**Addendum No. 1
December 8, 2021**

Project: Corsica-Stickney Elementary School Addition
Stickney, South Dakota
Architect's Project No.: 2910
Architect: Architecture Incorporated
Opening: December 16, 2021
2:00 pm CST
Elementary School Gymnasium

DEMOLITION BID PACKAGES

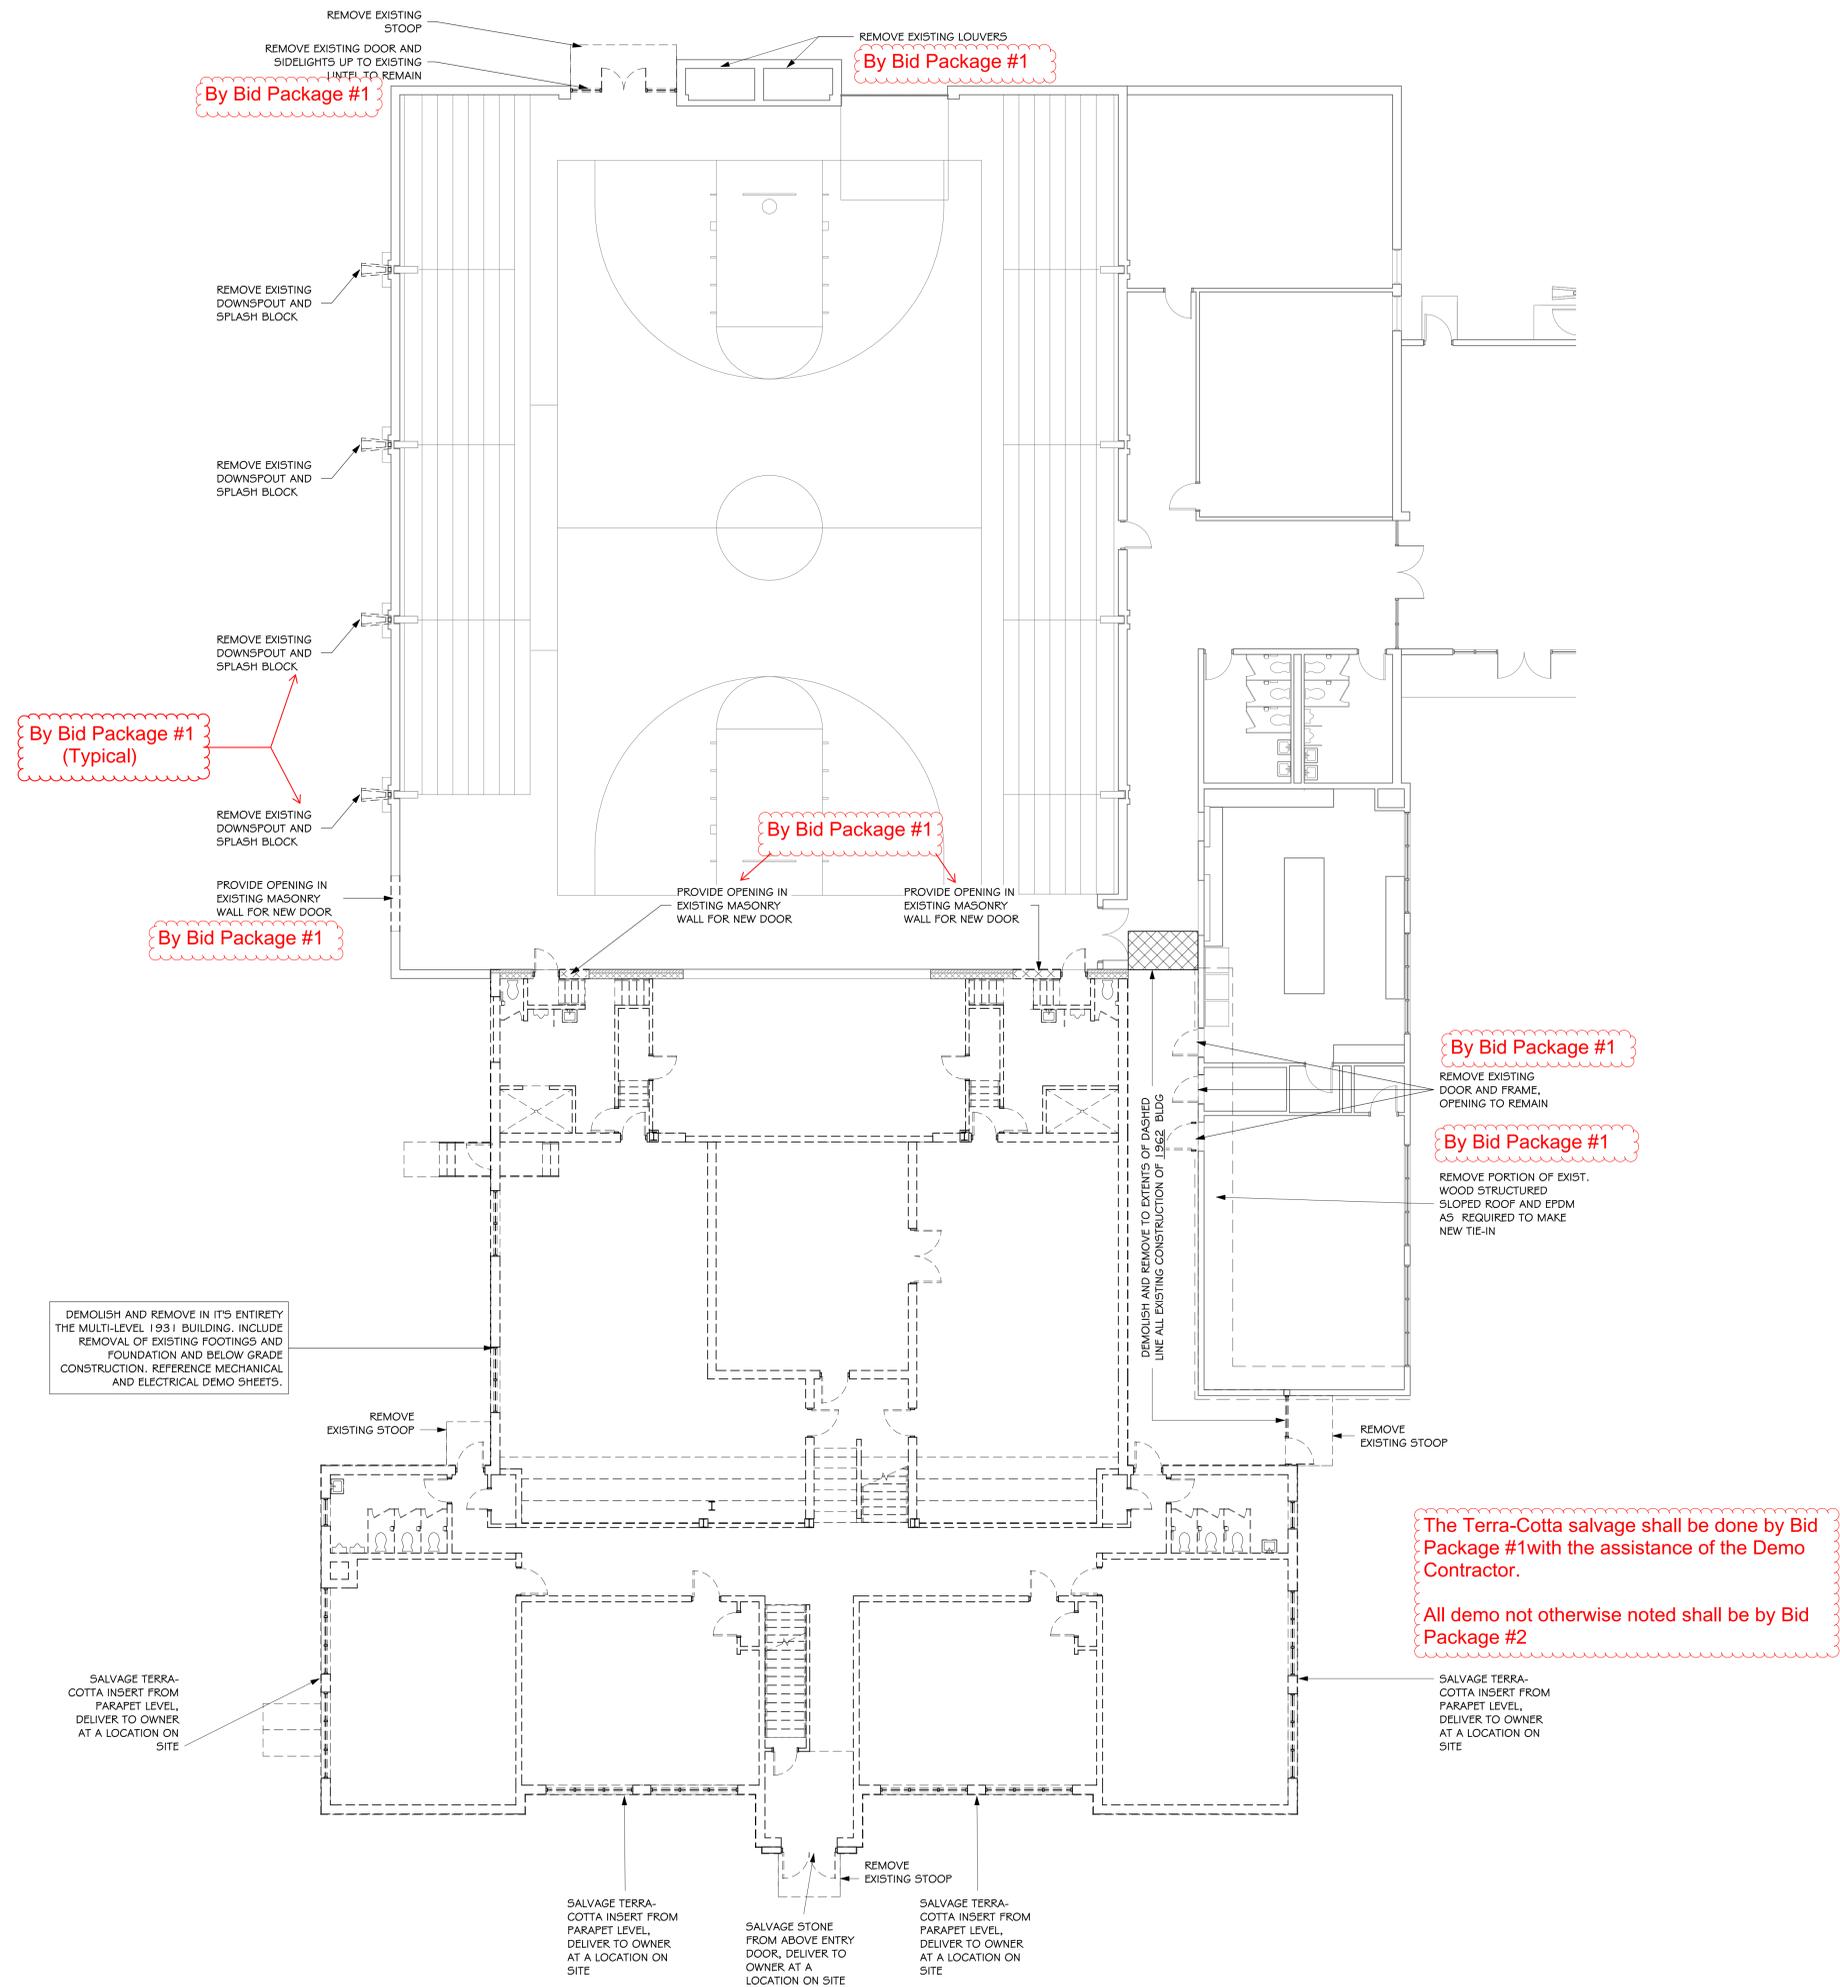
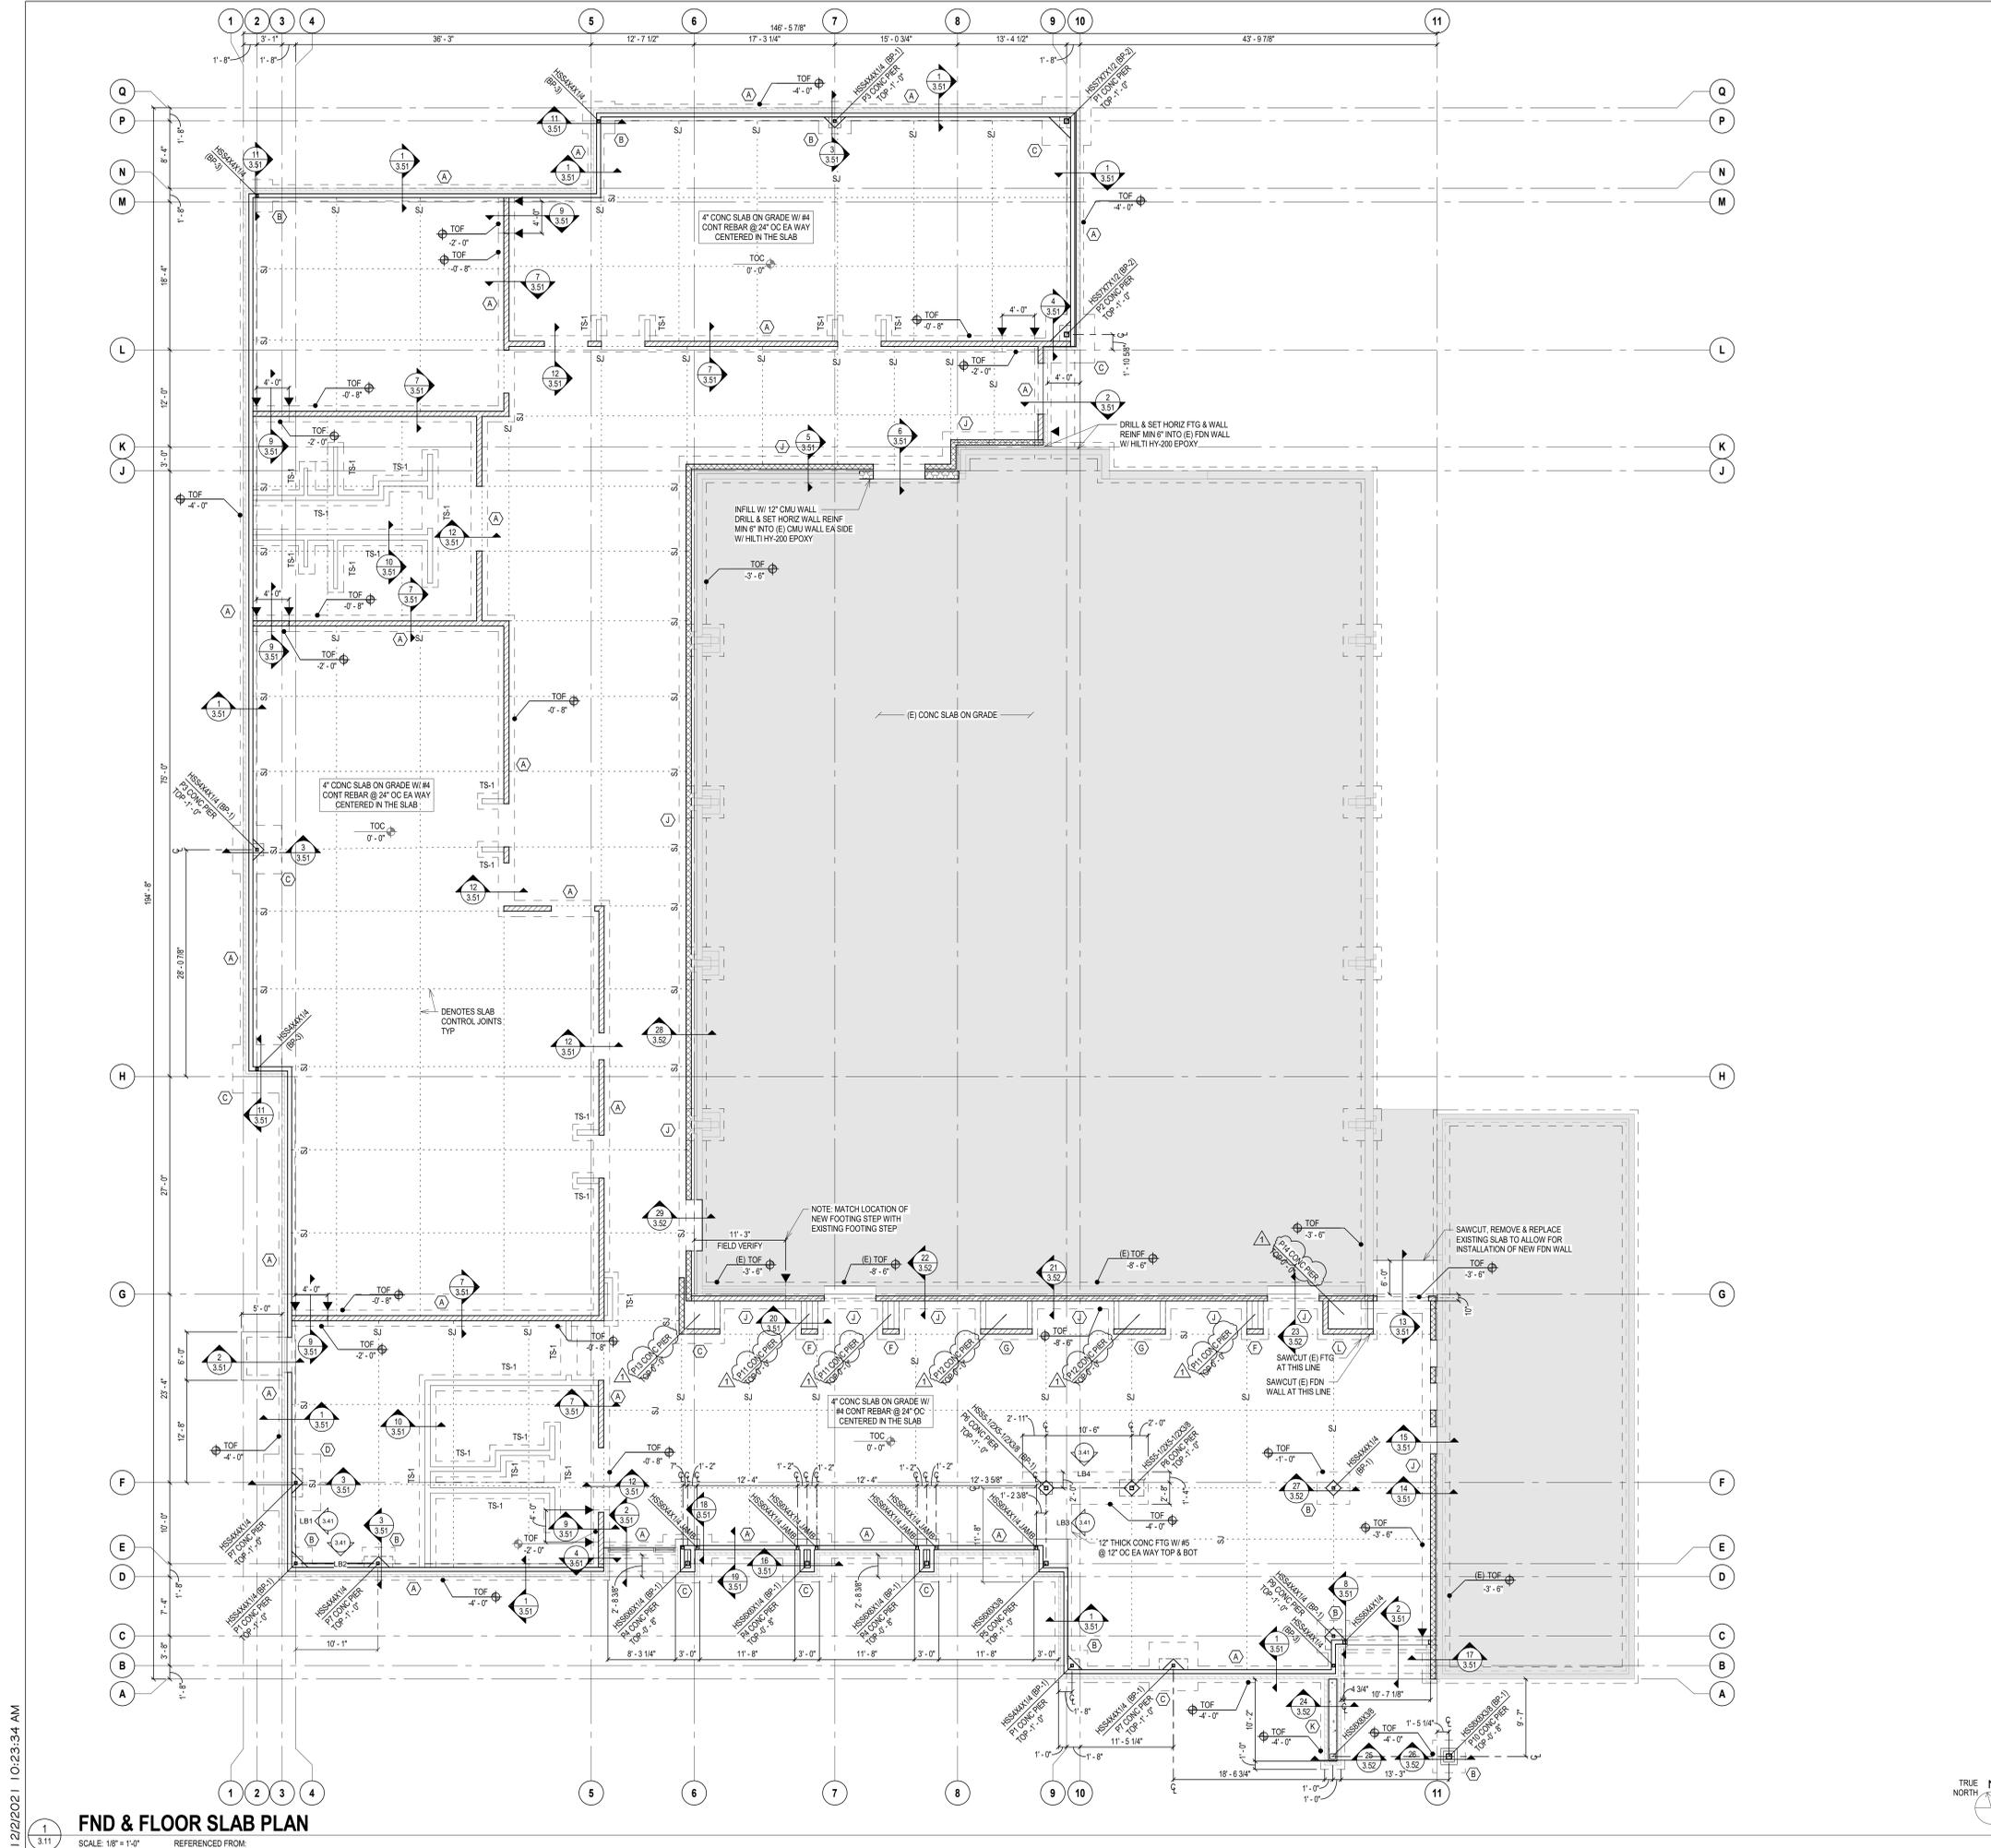
- 3) CONSTRUCTION MANAGER FRONT END: See Attached
- 4) STICKNEY LANDFILL AND HAUL ROUTE: See Attached
- 5) DEMOLITION BID PACKAGES: See Annotated 30x42 sheet 4.0 Attached

- iii. See attached Demo Sheet 4.00 for division of demolition responsibilities between Bid Packages 1 & 2.

S11
3.61
SCHEDULE - CONCRETE PIER
SCALE: NTS

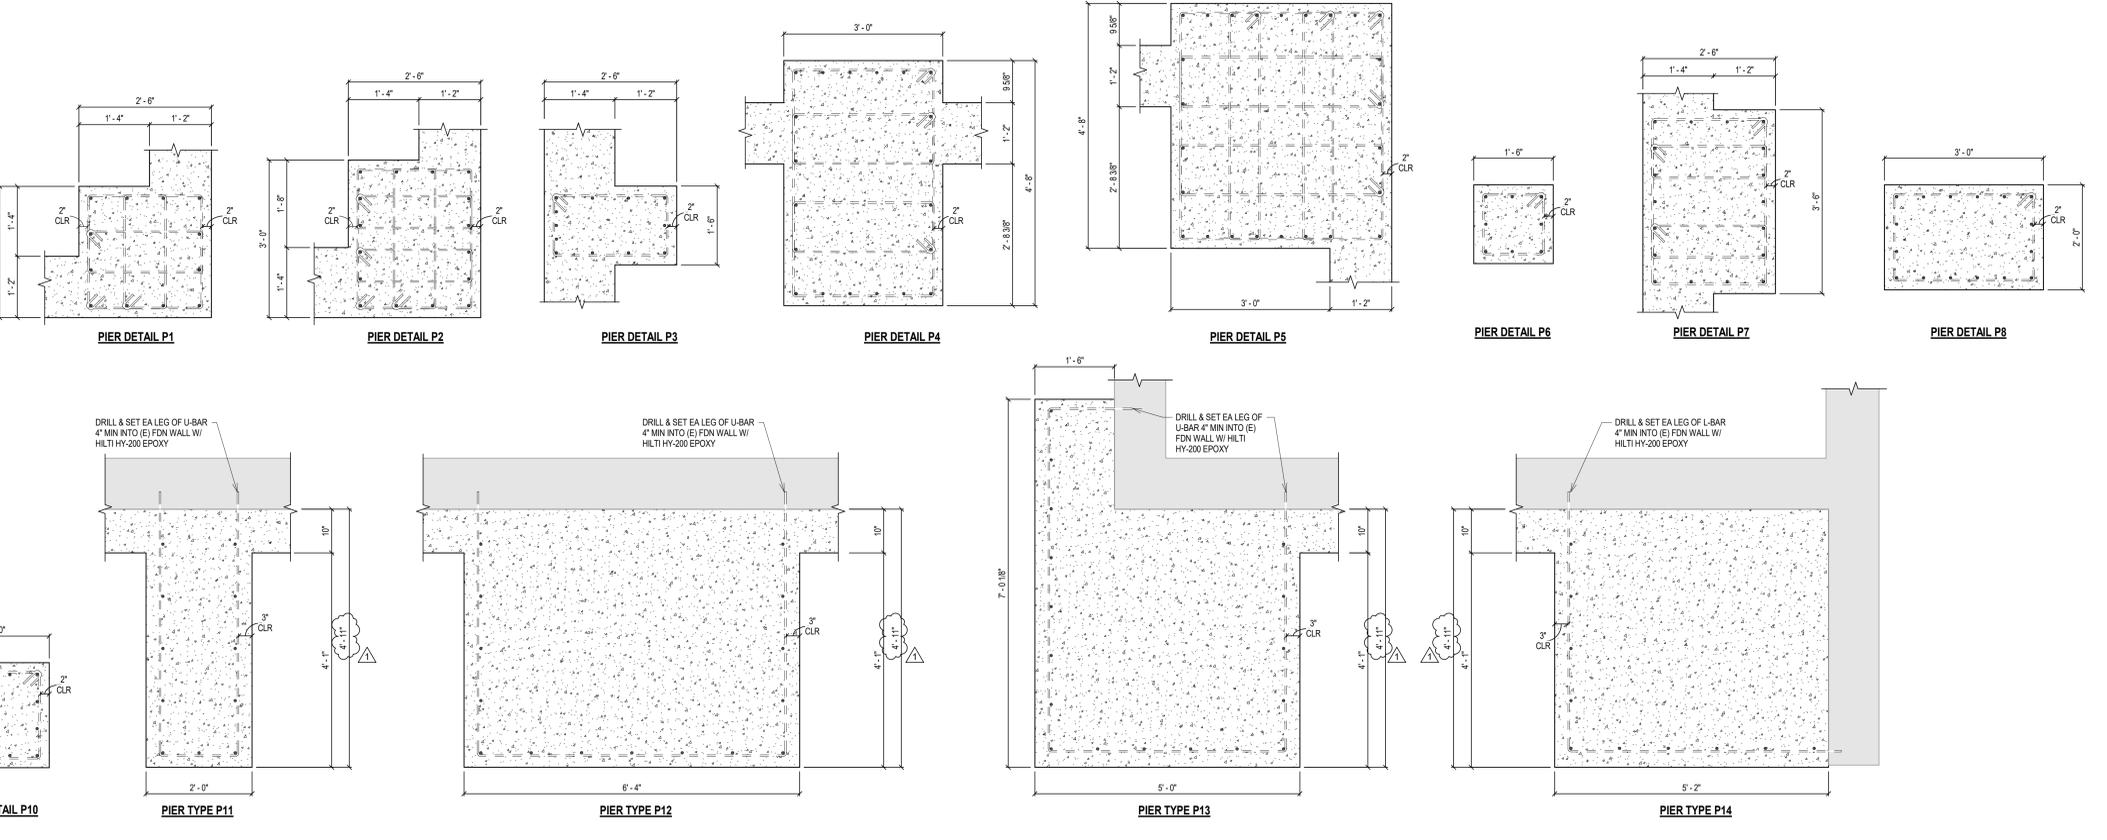
- a) **MODIFY** Concrete Pier Schedule
- 3) SHEET 4.10 OVERALL FLOOR PLAN: See new sheet with changes clouded and tagged with “1”
 - a) **ADD** notes to include temporary structure for egress of Phase 1 while Phase 2 is under construction.

1 OVERALL FLOOR PLAN
4.10 SCALE: 1/16" = 1'-0"

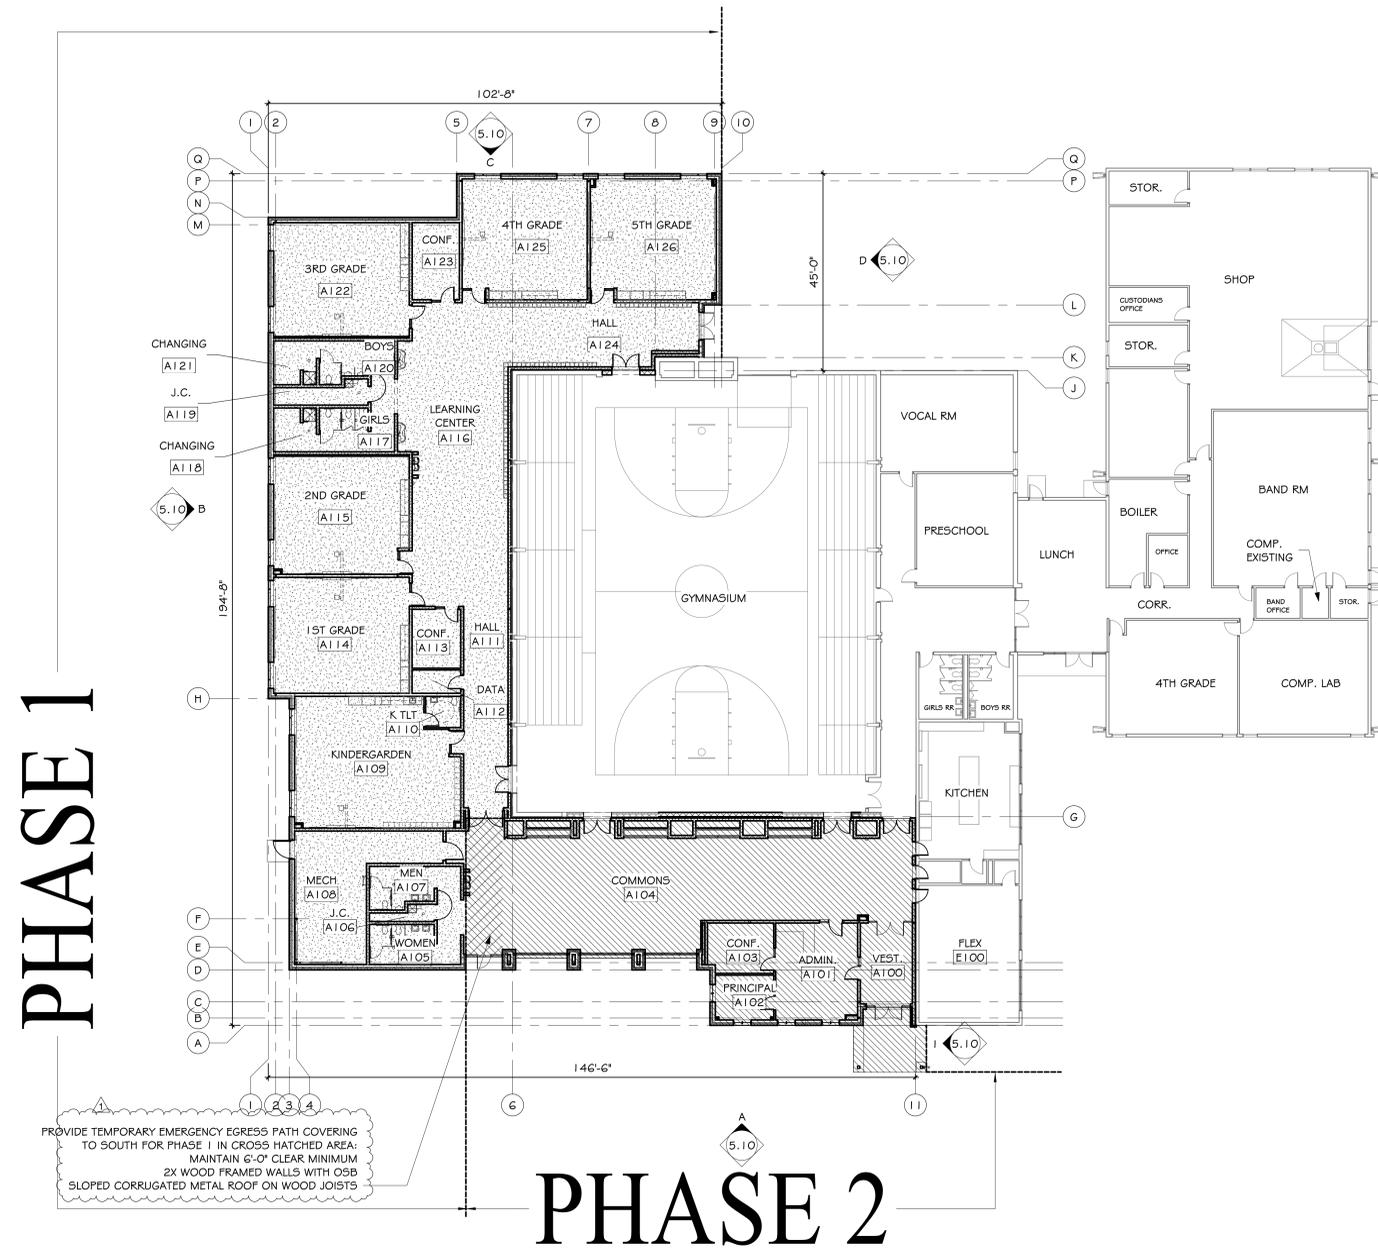
2. 061753 – Wood Trusses (Provide and install)
 - ii. The construction of the temporary egress shelter shall be by this Bid Package. See note on Plan Sheet 4.10 that is included in this addendum. A temporary door with a panic device shall be installed for use until the finishing phase when the permanent doors will be installed.

- i. This contractor shall be responsible for temporary lighting for the temporary egress shelter noted on Sheet 4.10 that is a part of this addendum.
